MONITORING YEAR 2 ANNUAL REPORT FINAL

CARPENTER BOTTOM MITIGATION SITE

RE: Carpenter Bottom Draft MY2 Report Review
Catawba River Basin - HUC 03050102 (03050103 Expanded Service Area)
Gaston County
DMS Project ID No. 100090
Contract #7731

FIGURES

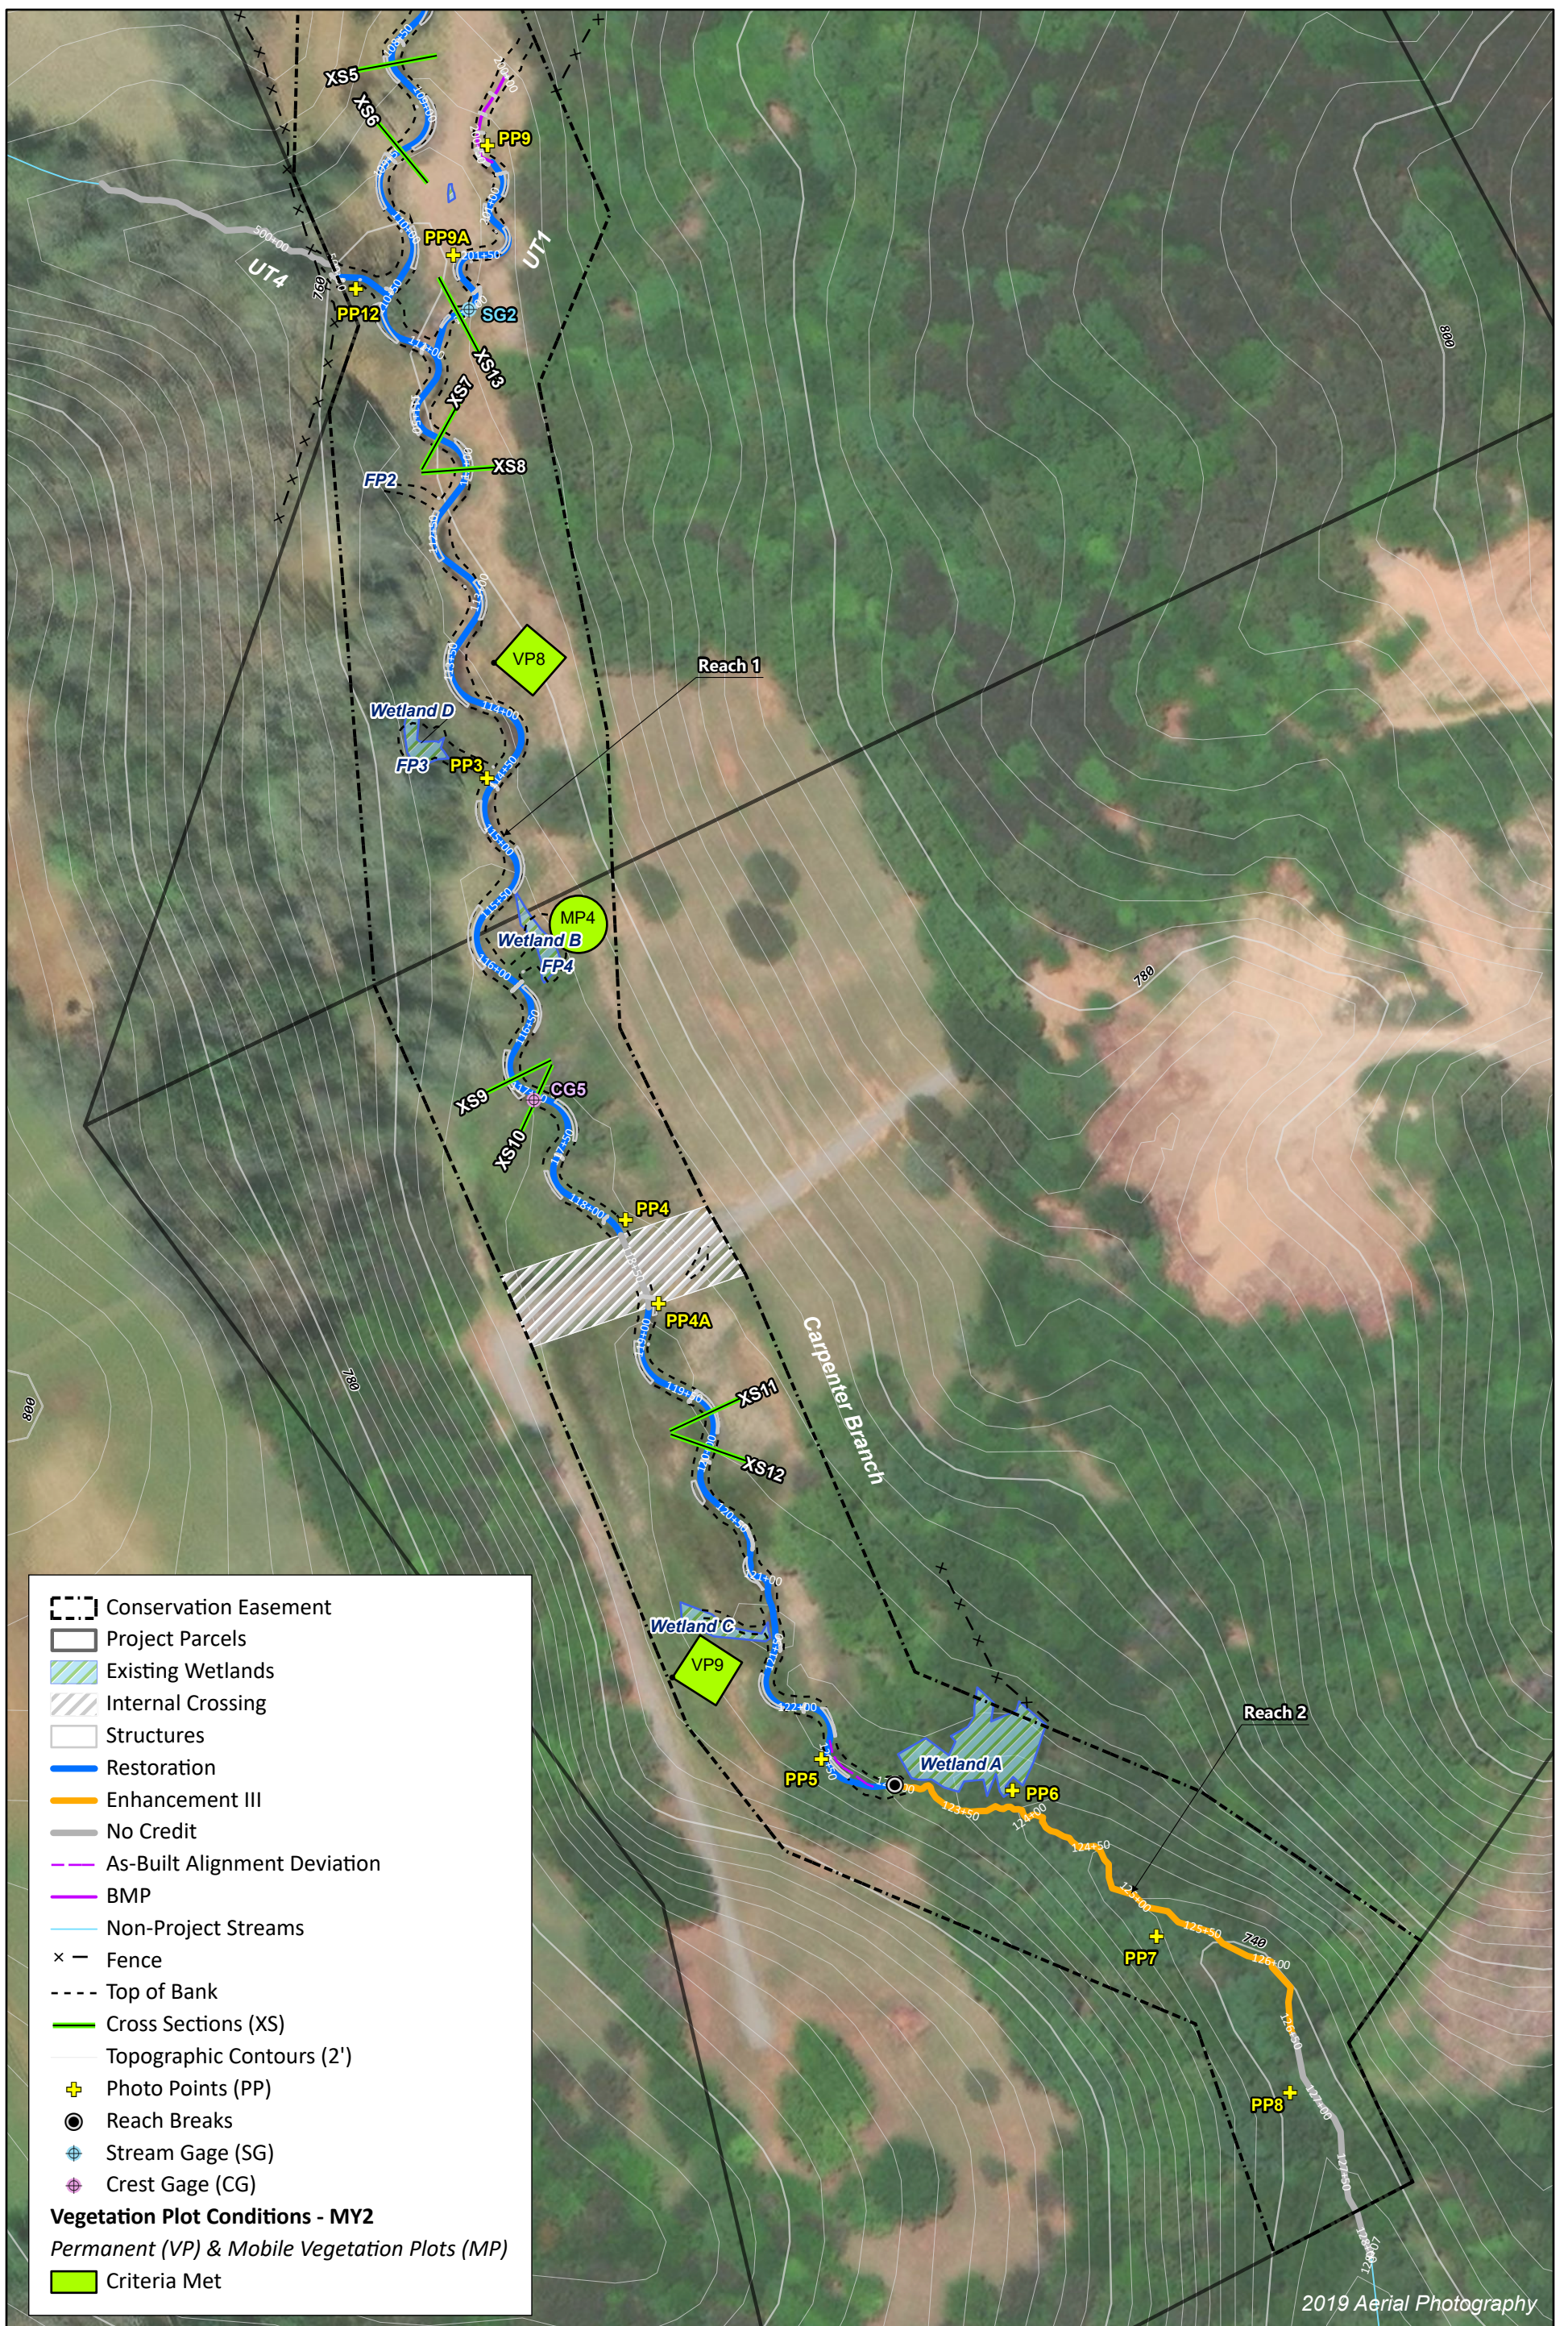
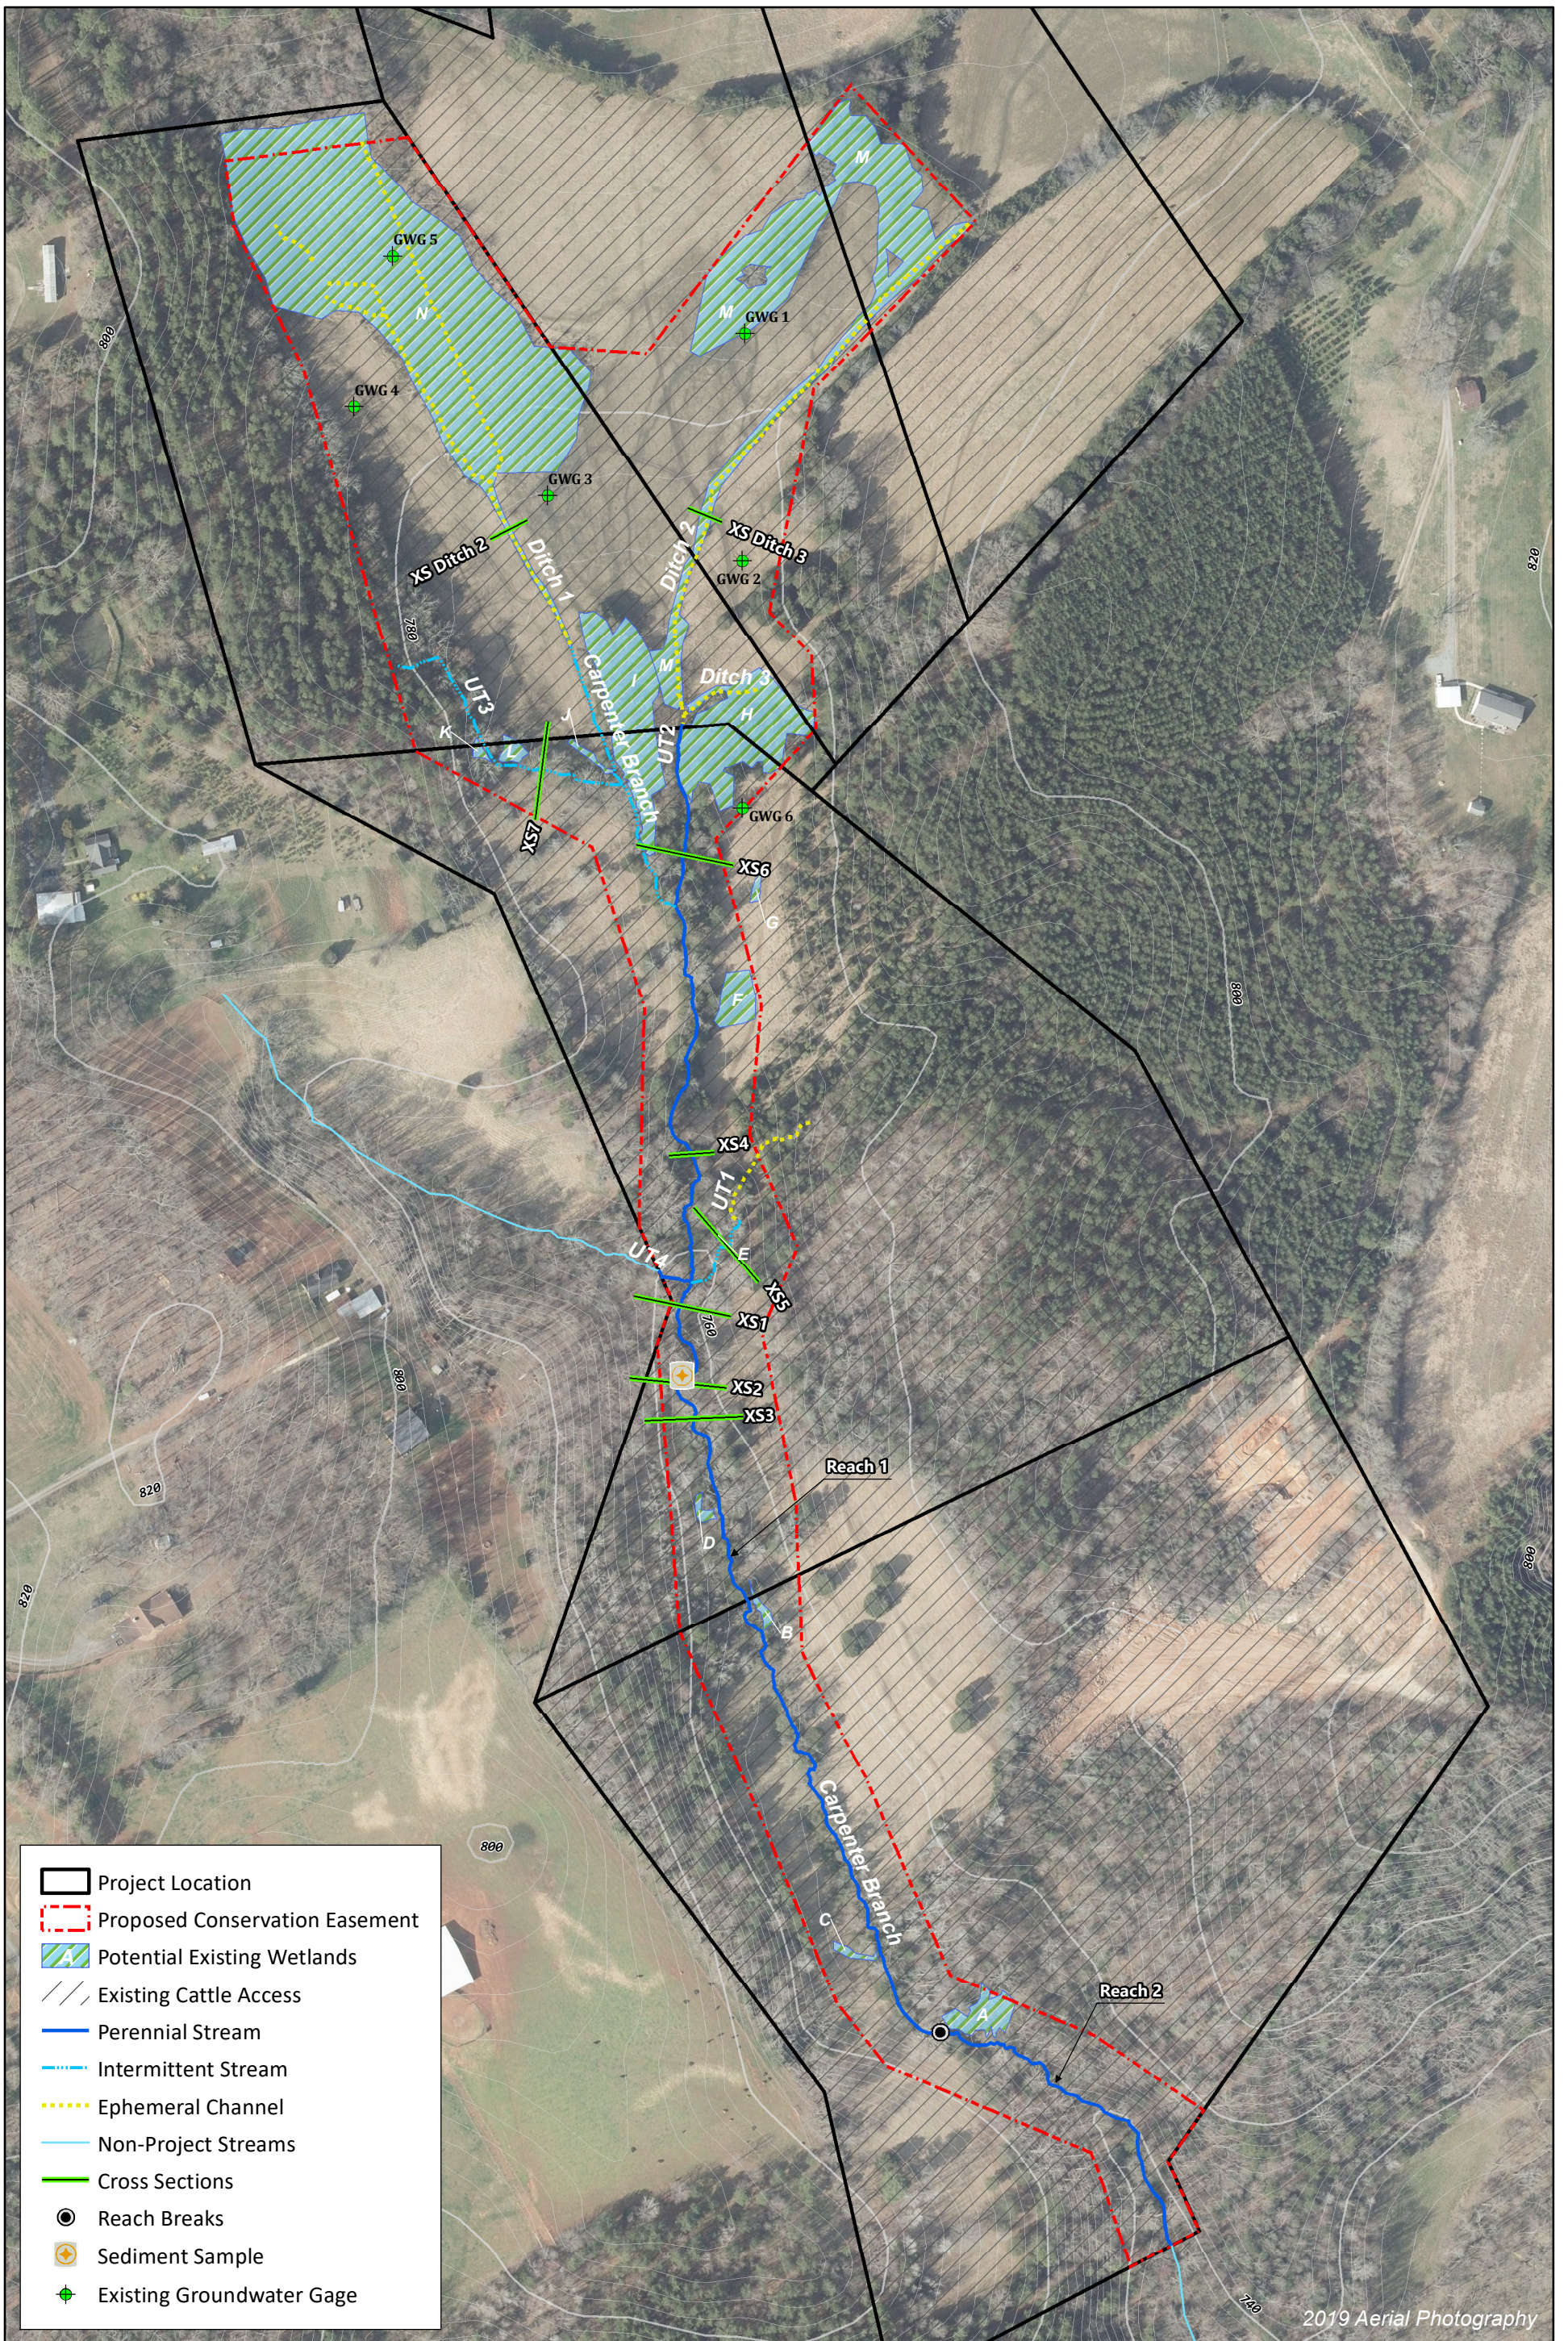
DMS Comment: Recommend either including Figure 3 from the Mitigation Plan and/or adding the six gauges shown in Table 12a to the CCPV so reviewers can easily see the location of the existing conditions gauges compared to the locations of the current monitoring gauges.

Wildlands' response: "Figure 3. Site Map (Mitigation Plan)" was added to the report after the CCPV figures. In addition, the six groundwater gages from the Mitigation Plan are included in the submitted geodatabase.

Monthly Rainfall Data

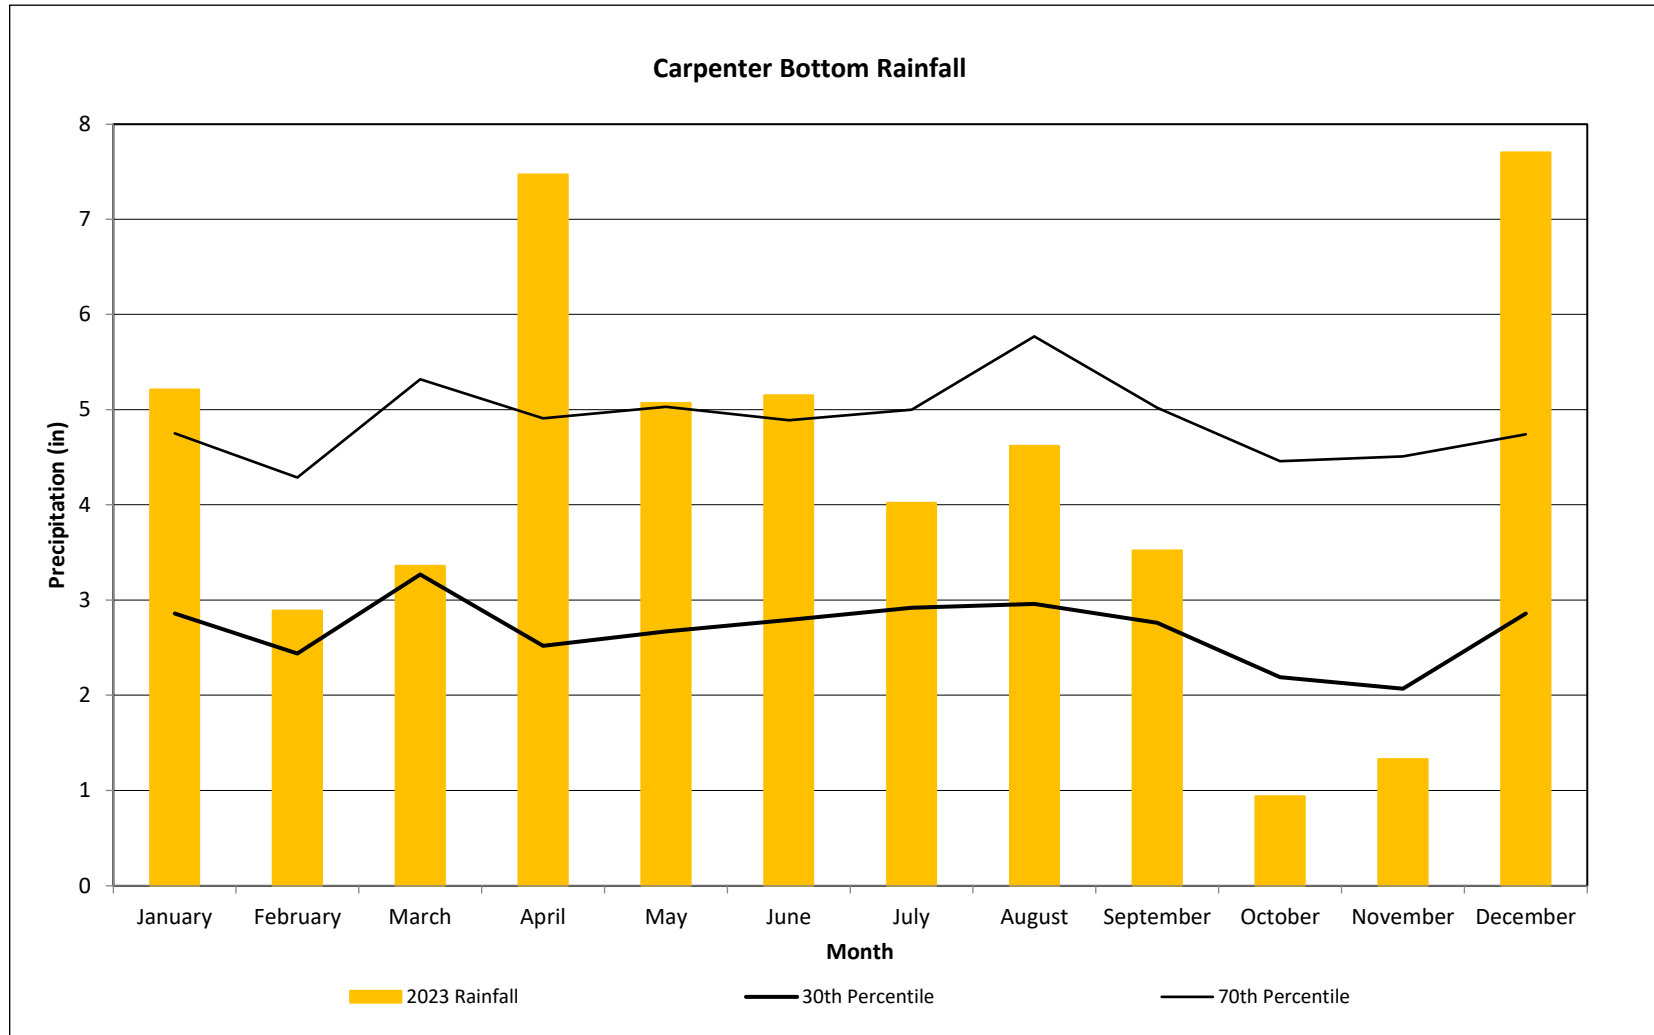
DMS Comment: Table 11: If possible, please update the rainfall summary table with end of year data for final submittal.

Wildlands' response: The rainfall table (table 11) and the Monthly Rainfall Data plot were updated to include all of 2023. With a 4.7" rain event at the end of December and 7.7" of rain for the month, the annual rainfall totaled about 2" more than the normal annual rainfall. The end of year rainfall was enough to bring Gaston County to an Abnormally Dry D0 status. Any impact on groundwater storage should be visible in the next monitoring year.
